MUNCIE POWER PRODUCTS

Product Bulletin #00035

Subject: New RVC kit for V080 & V130 valves (for use with detent options)

Date: Feb. 28, 2017

Note:
Number of Items in Detent
Kit will vary depending on
kit in use. (V080BC08 kit shown)

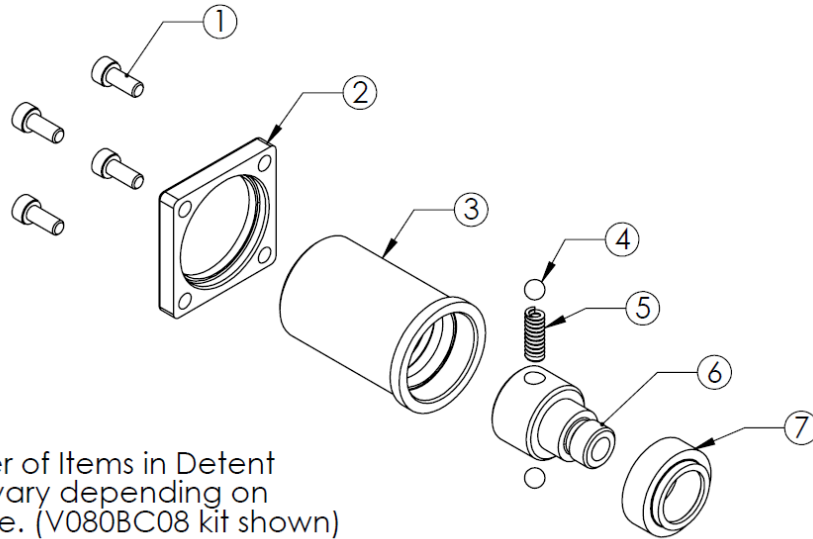
The new RVCHK233S1 was created to reduce the shift force out of the detented position while using a cable shift option. The new RVCHK233S1 kit includes a "soft" detent spring (P/N 0602025333M1) that can be used to replace the "standard" detent spring. Making use of the "softer" spring makes it easier to shift the valve spool back to neutral.

“Item 5” is the detent spring that must be replaced with the new
“soft” spring, P/N 0602025333M1.

The new RVCHK233S1 is the recommended kit for the V080 and V130 valve when a detent is also being used. For cable shifted valves that do not use a detent, the standard RVCHK233 is still the best option.
